January 27, 2025

RE: Seeley Reservoir Stockpiles, File No. # M-2023-043, New 112c Application, Adequacy Review-1

RE: Seeley Reservoir Stockpiles, File No. M-2023-043 (Adequacy Review/Additional Application Comments)

**RE: Review of the Ogilvy Ditch Company
Structure Keirnes Land Company, LLC/Eagle
View Farms, LLC Weld County, Colorado**

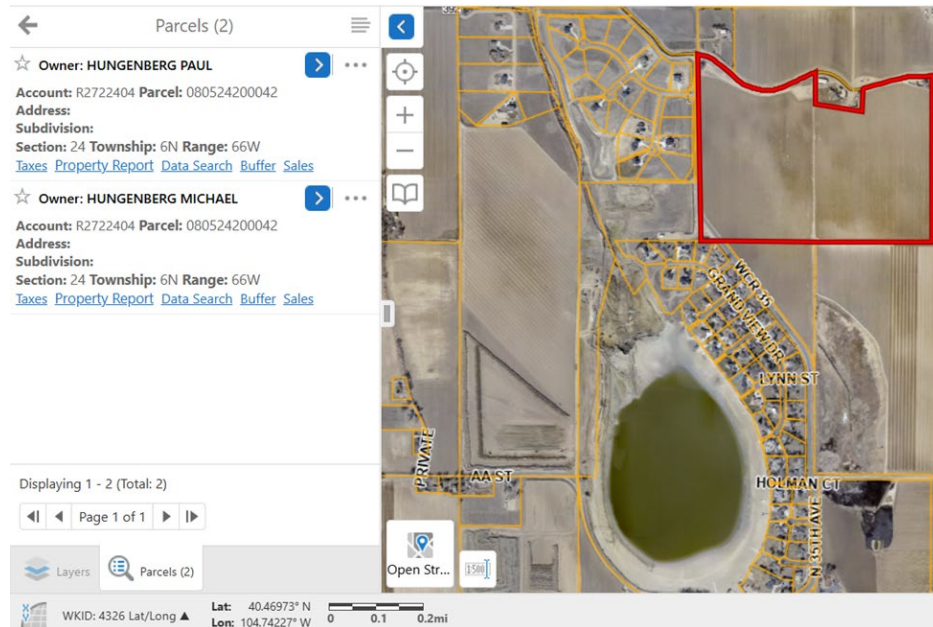
- Please indicate the location and orientation of the sediment basin on the Exhibit C Maps.
7. On the Pre-Mining M-1 map and the Mining Plan M-2 map, at least one property parcel (located northeast and adjacent to the Applicant's affected land) does not appear to indicate the property owner(s) (see screenshot below).

- Please provide the names of all adjoining surface owners of record, pursuant to Rule 6.4.3(a).

Exhibit 1 (Continued) Images # 1 - 4

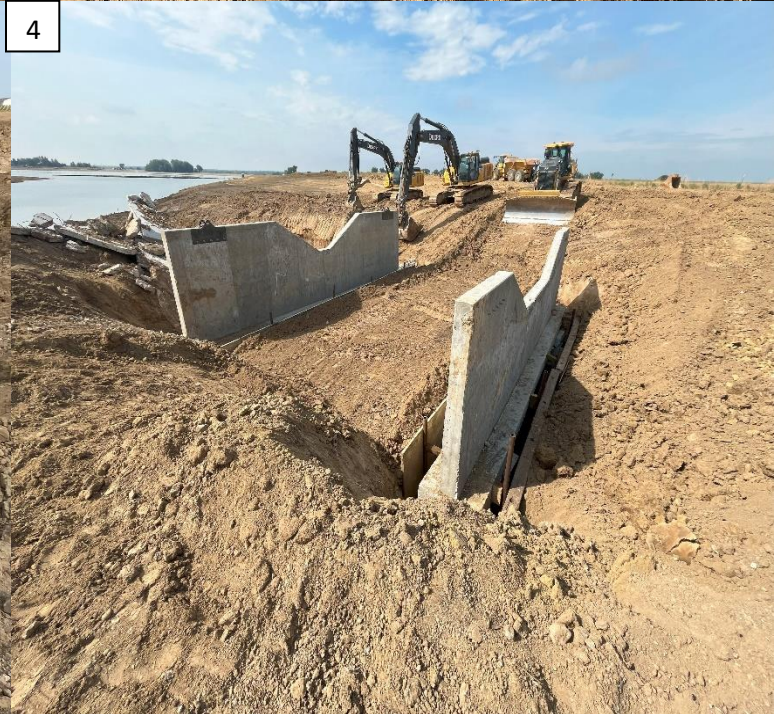
- Image 1 - Shows the first unapproved failed structure and damages caused, due to the non-engineering (as stamped engineered plans were nonexistent). Our general observations contradict the claimed cause of failure and we believe it was due to head wall pressure by damming up the historical flow of water.

Exhibit 1 (Continued) Images # 5 - 8

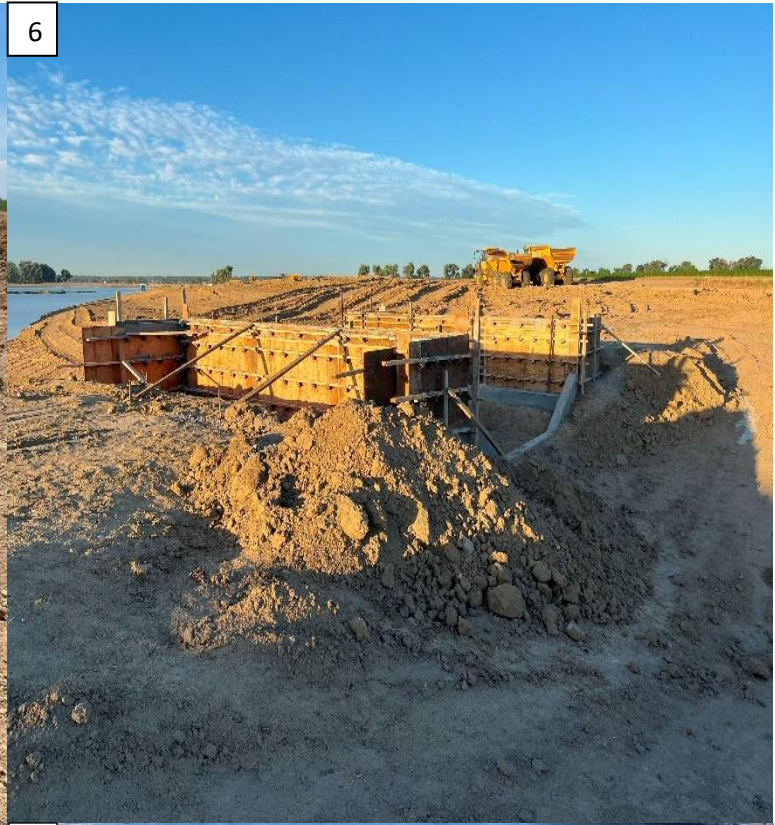
- Image 8 – Show the subject areas' historical positive flow of water down gradient to the Seeley Lake Reservoir, before creating the new detained body of water outside of the reservoirs original foot print shown in image 7.
